# Ridge Street shared user bridge connection and Alfred Street North road design options Community Consultation Outcomes Report

# Warringah Freeway Upgrade

Project Number:	N1098
Revision date:	8/06/2023
Revision:	Rev A

### Plan View Alfred Street North - Approved WFU Design

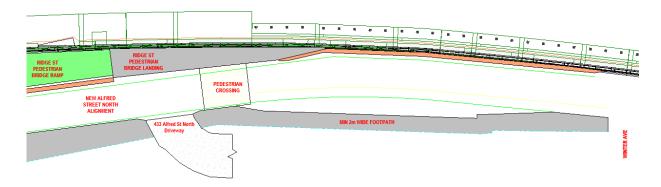
The result of investigations by the WFU design team confirms that the EIS approved southbound bus lane, retaining wall and freeway widening cannot be completed and operate combined with the 433 Alfred Street North design proposal due to the restricted area available in this location.

The spatial constraints mean that retaining parking as outlined in the proposal is not achievable.

#### Plan View – 433 ASN Design Proposal with Approved WFU Design

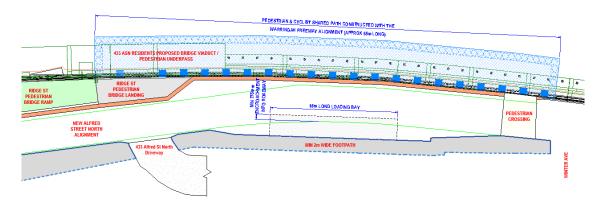
Image 3: showing resident design proposal over available space for road layout. Blue area is outside of available space

The plan view and cross section images show that the 433 Alfred Street North stakeholder proposal encroaches into the existing Warringah Freeway while not allowing retention of on-street parking. The 433 Alfred Street North stakeholder proposal provides a very constrained (in height and width) undercover shared path with limited passive surveillance which may lead to public safety concerns.

The cantilever structure proposed by 433 ASN would be required to be constructed in the southbound freeway traffic lane. This would result in major road closures of the Warringah Freeway to allow piling works to proceed.

Although the 433 ASN design proposal is not feasible due to the design constraints, following feedback from 433 Alfred Street North to date, the following design refinements are being investigated for construction by the project team:

- 1. Retaining the loading bay /set down area adjacent to 433 Alfred Street North
- 2. Review of road levels in front of 433 Alfred Street North driveway alignment to improve visibility and manoeuvrability at exit
- 3. Consideration of installation of rumble strips and speed humps south of the 433 Alfred Street North driveway to slow approaching vehicles
- 4. Consideration of localised road narrowing with planted medians on the approach to 433 Alfred Street North driveway to further slow approaching vehicles
- 5. Opportunities for additional safety measures such as a mirror and signage will be reviewed and developed specifically for the 433 Alfred Street North driveway
- 6. Provision of enhanced accessible path between 433 Alfred Street North and the proposed lift to access the pedestrian bridge crossing Warringah Freeway to connect directly to Ridge Street.
